JLG Architects
 Ross McIntyre, Assoc. AIA
 801 Washington Avenue North Unit 120
 Minneapolis, MN 55401
 p. 612.746.4260 d. 612.436.4009 c. 651.283.6031
 rmcintyre@jlgarchitects.com
JLG 13070B-5A Construct New IT Center
St Cloud VAHCS Proj. No. 656-14-246
 RE: Amendment No. 6
 December 10, 2015

Amendment No.6

Please issue the following changes to the contract documents as Amendment No. 6 for the Construct New IT Center for Healthcare Management Expansion Project at the St. Cloud, MN VAHCS (Project No. 656-14-246)

AMENDMENT NO. 6
October 12, 2015
DTE Project #02213008

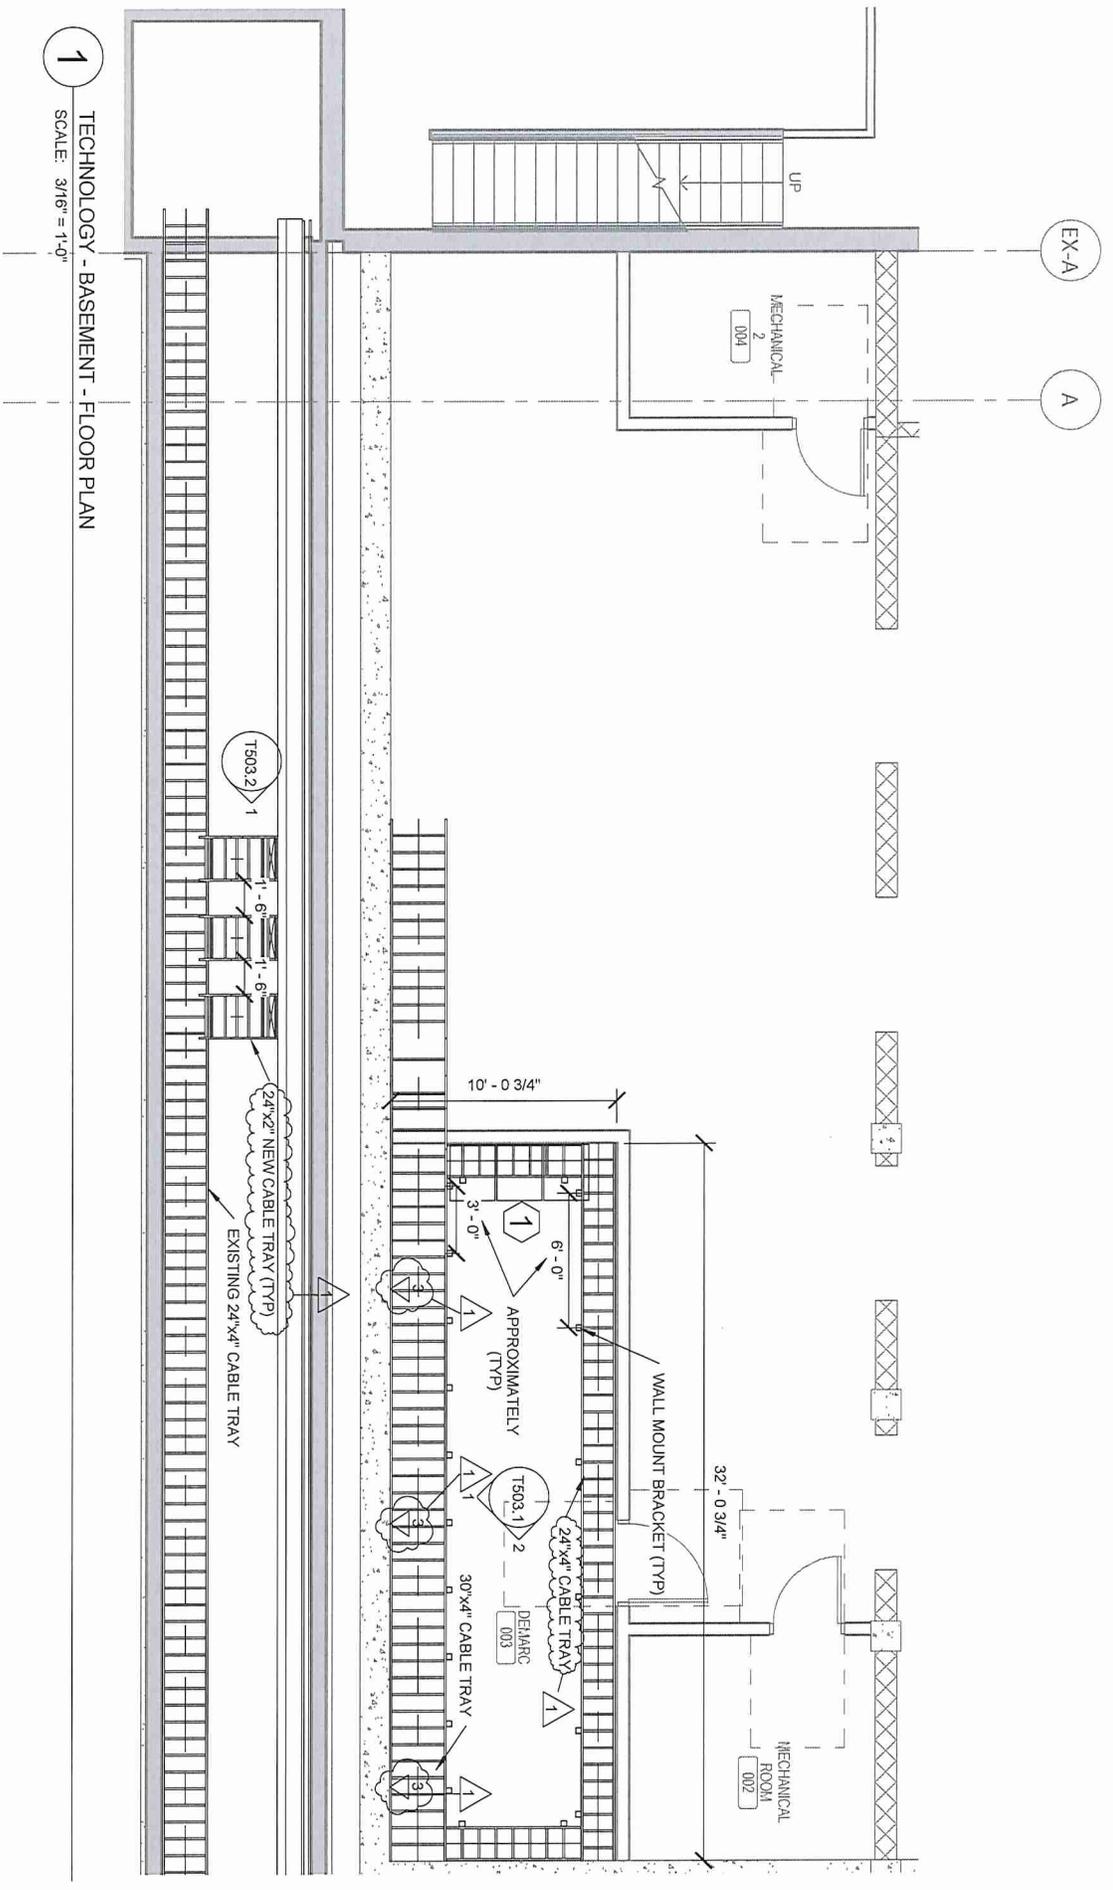
5. Sheet T502 detail 2 "COPPER CONNECTIVITY DIAGRAM" Change the pairs count of the existing copper backbone cable installed to Room 103 in Building 50 from 200 pairs to 100 pairs.

TECHNOLOGY - BASEMENT - FLOOR PLAN
 SCALE: 3/16" = 1'-0"

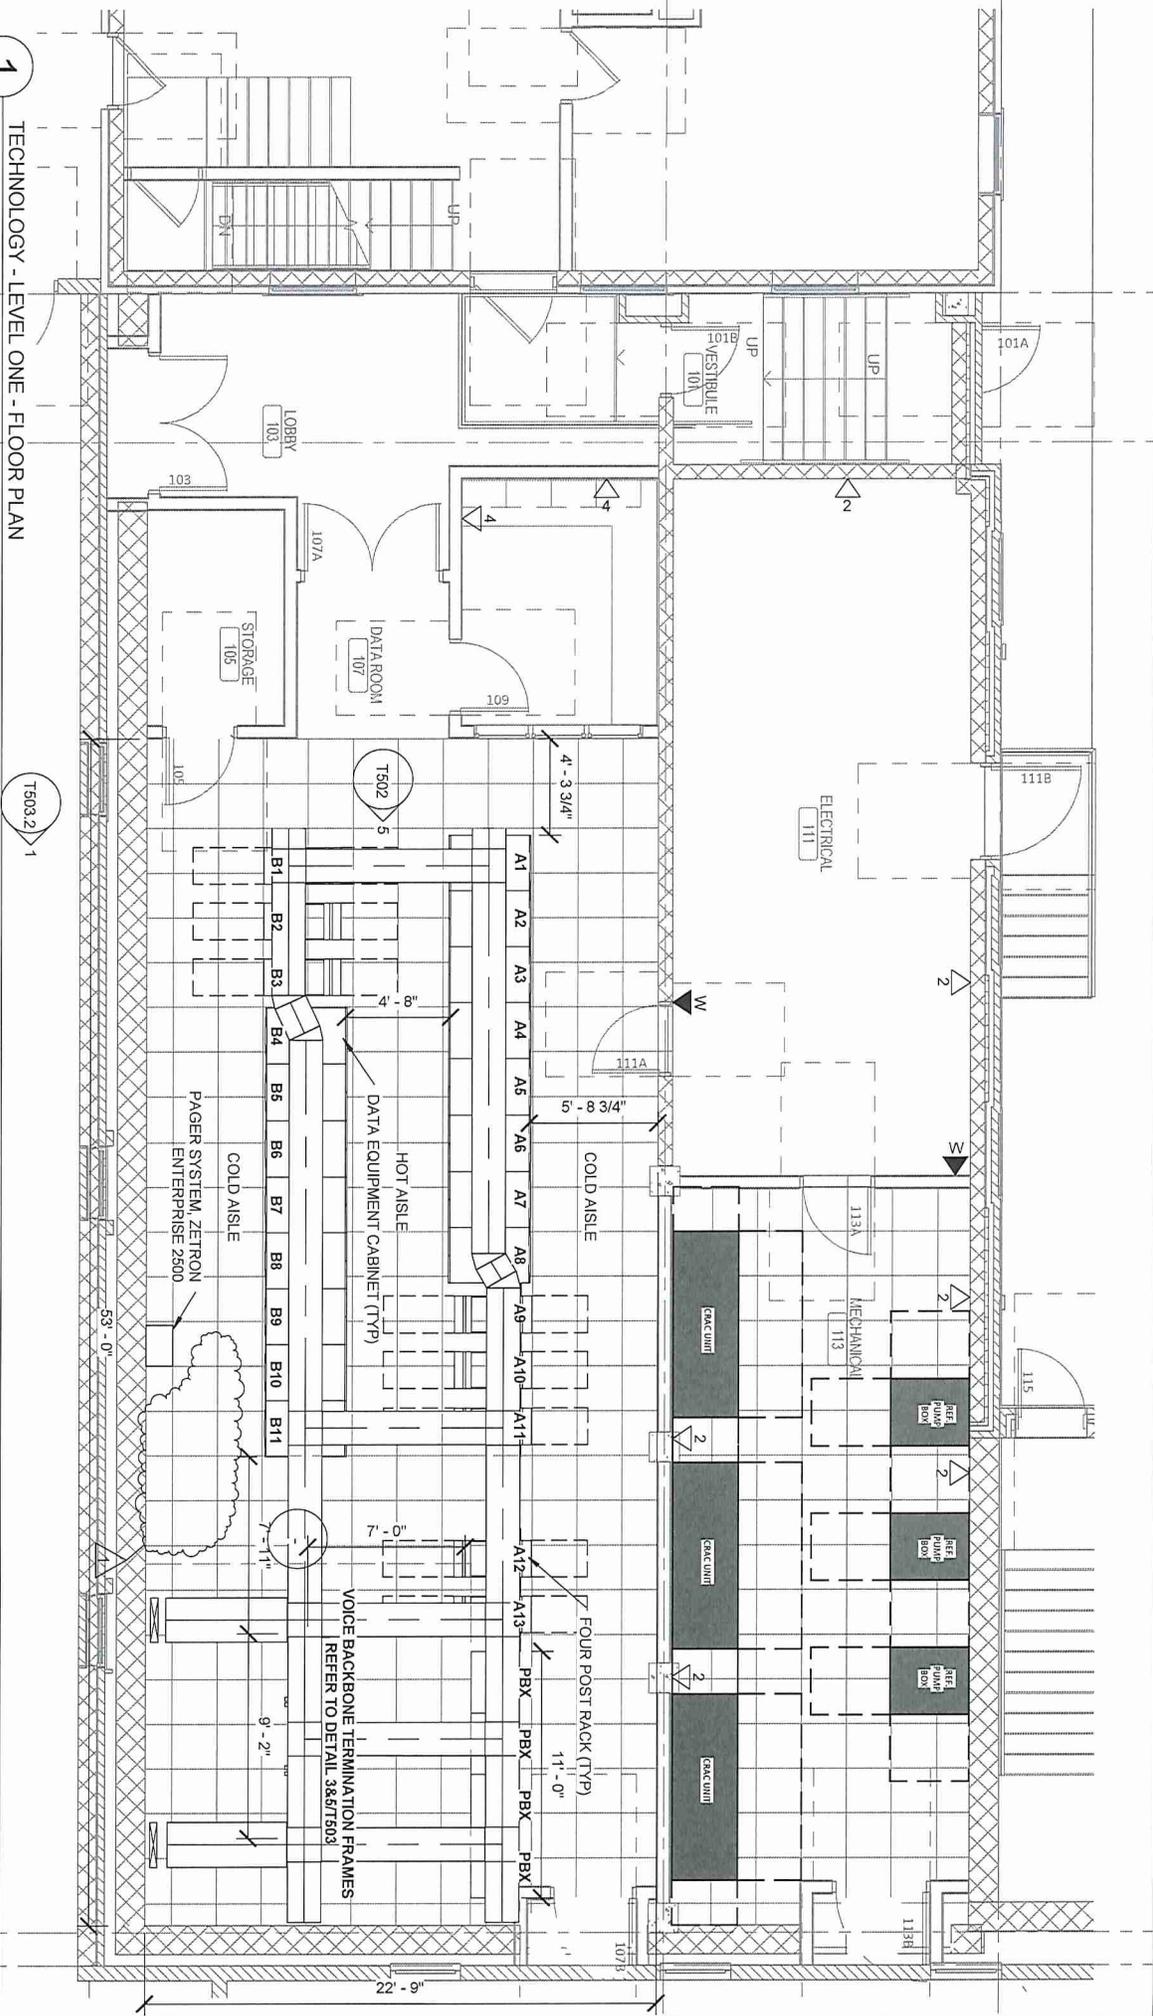
9. Sheet T101. Replace detail drawing 2/T101 with detail drawing Addendum 6 T101.1.
10. Sheet T101. Replace drawing 1/T101 with detail drawing Addendum 6 T101.2.

TECHNOLOGY - BASEMENT - DEMARC - SECURITY

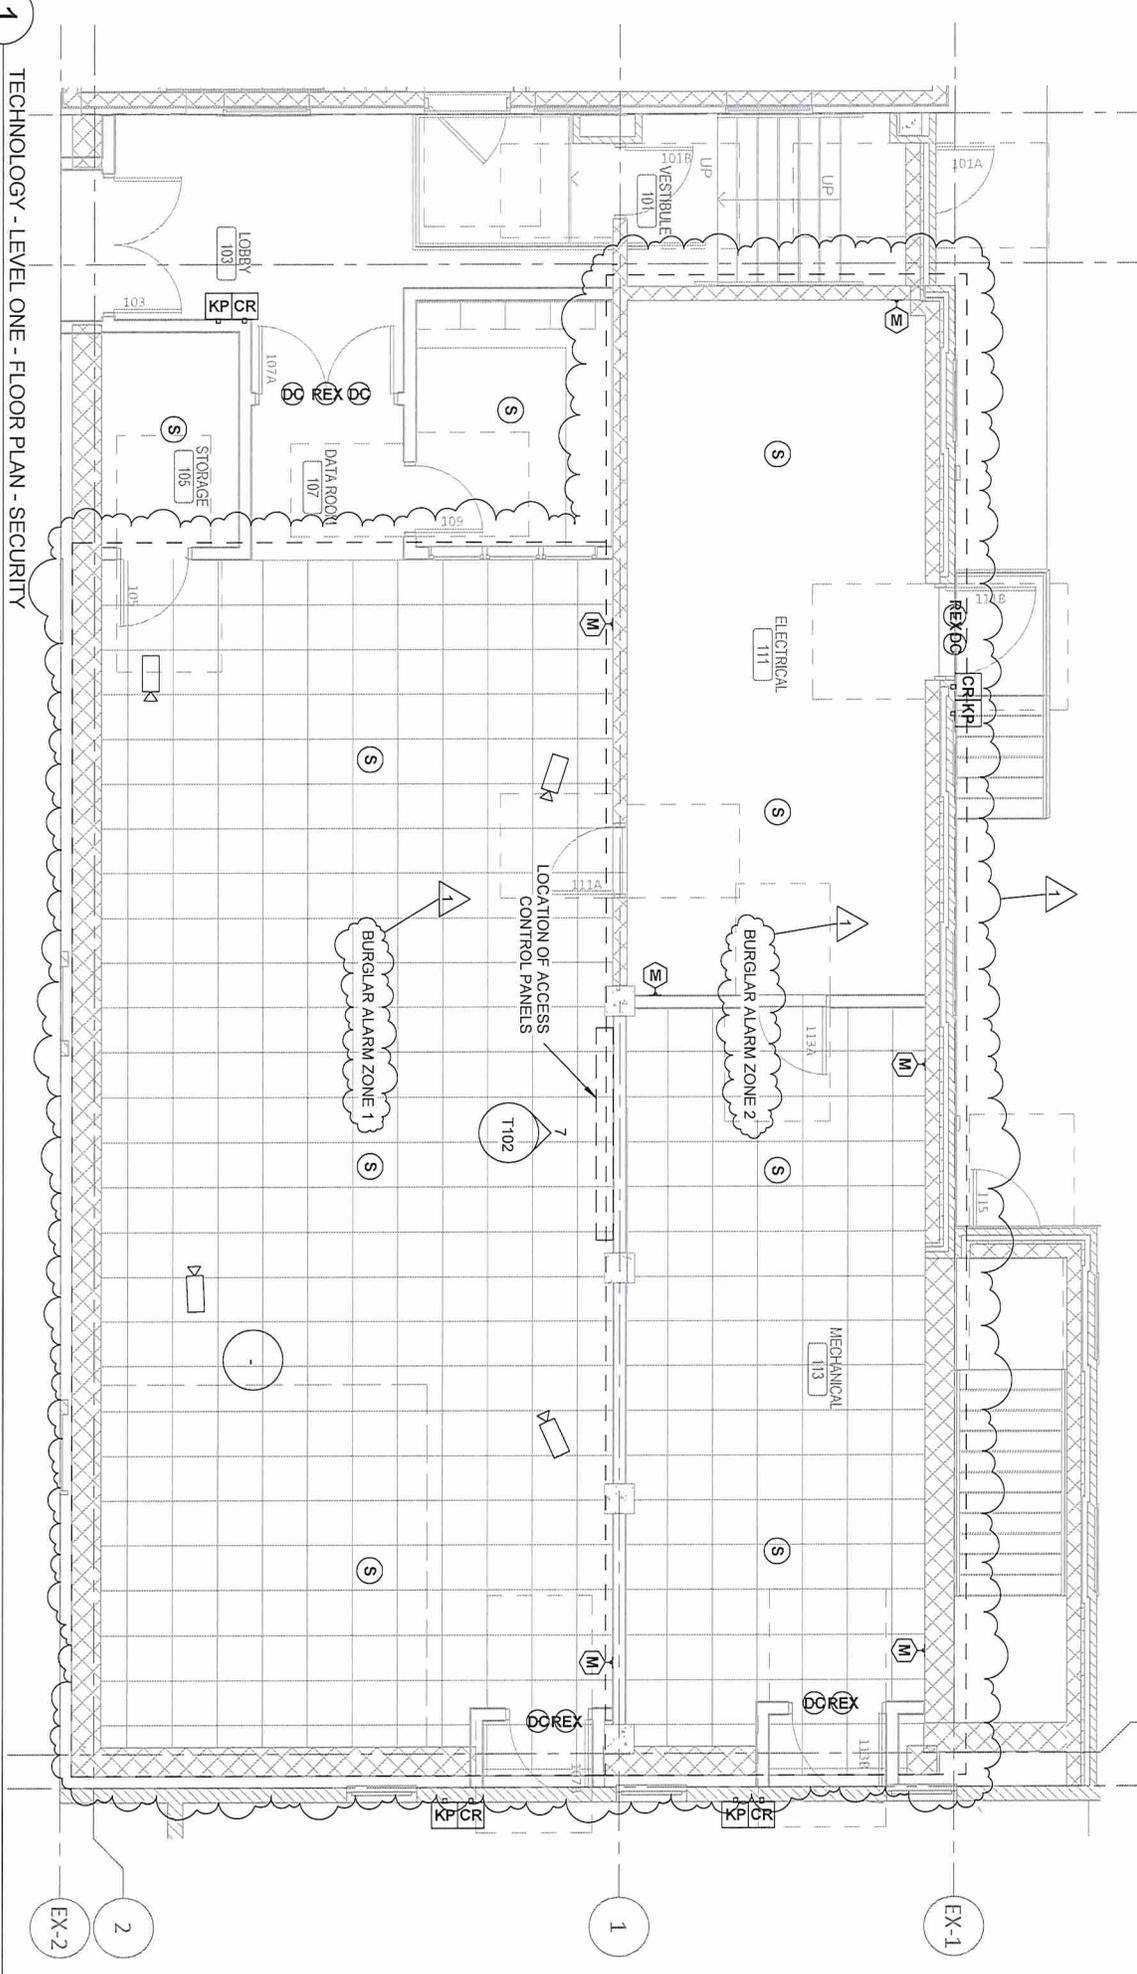
- A220 Note: Frame Type 1 as shown indicates to see schedule for width of frame. Frame type 1 can be for a single or pair of doors.
- A220 Add note below Door Schedule: Reference drawing T102.2 and T102.1 (issued as part of Amendment No. 6) for keypad card reader locations.

11. Sheet T102. Replace drawing 6/T102 with detail drawing Addendum 6 T102.1.
12. Sheet T102. Replace drawing 1/T102 with detail drawing Addendum 6 T102.2.

COPPER AND FIBER CONNECTIVITY DIAGRAM
 SCALE: NTS

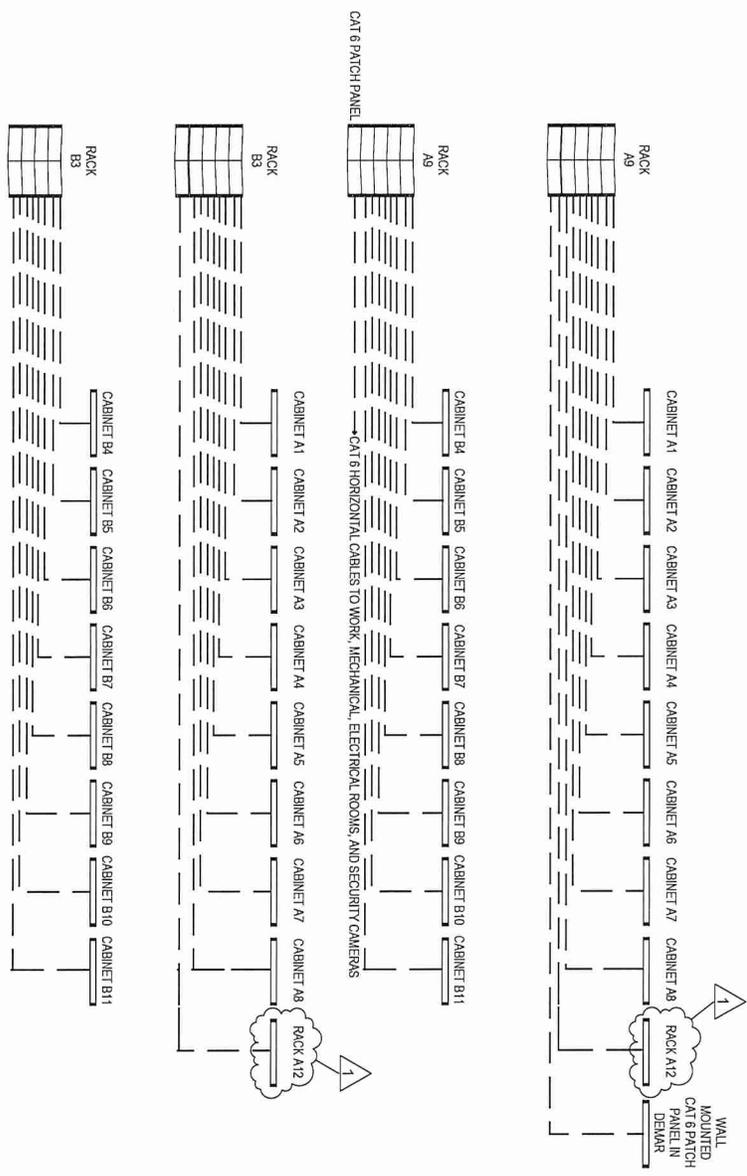
13. Sheet T501. Replace copper connectivity diagram with drawing Addendum 6 T501.1.
14. Sheet T502. Replace fiber backbone diagram with drawing Addendum 6 T502.1.

Dependent on DEMARC SOUTH WALL ELEVATION
SCALE: 3/8" = 1'-0"

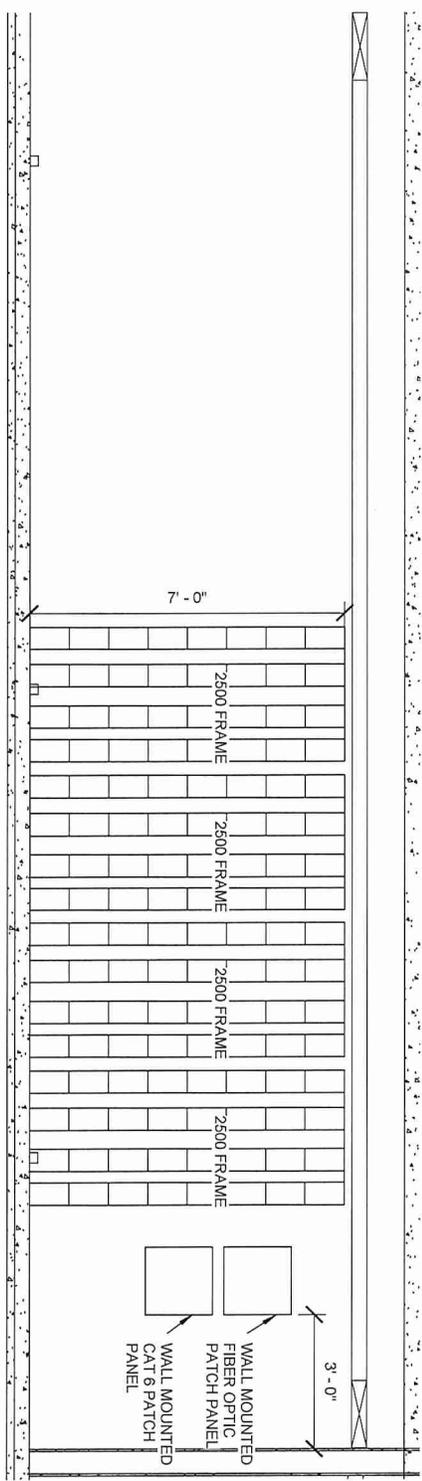
15. Sheet T503. Replace Demarc South Wall Elevation with drawing Addendum 6 T503.1.
16. Sheet T503. Replace Steam Tunnel Penetration and Cable Tray Elevation with drawing Addendum 1 T503.2.
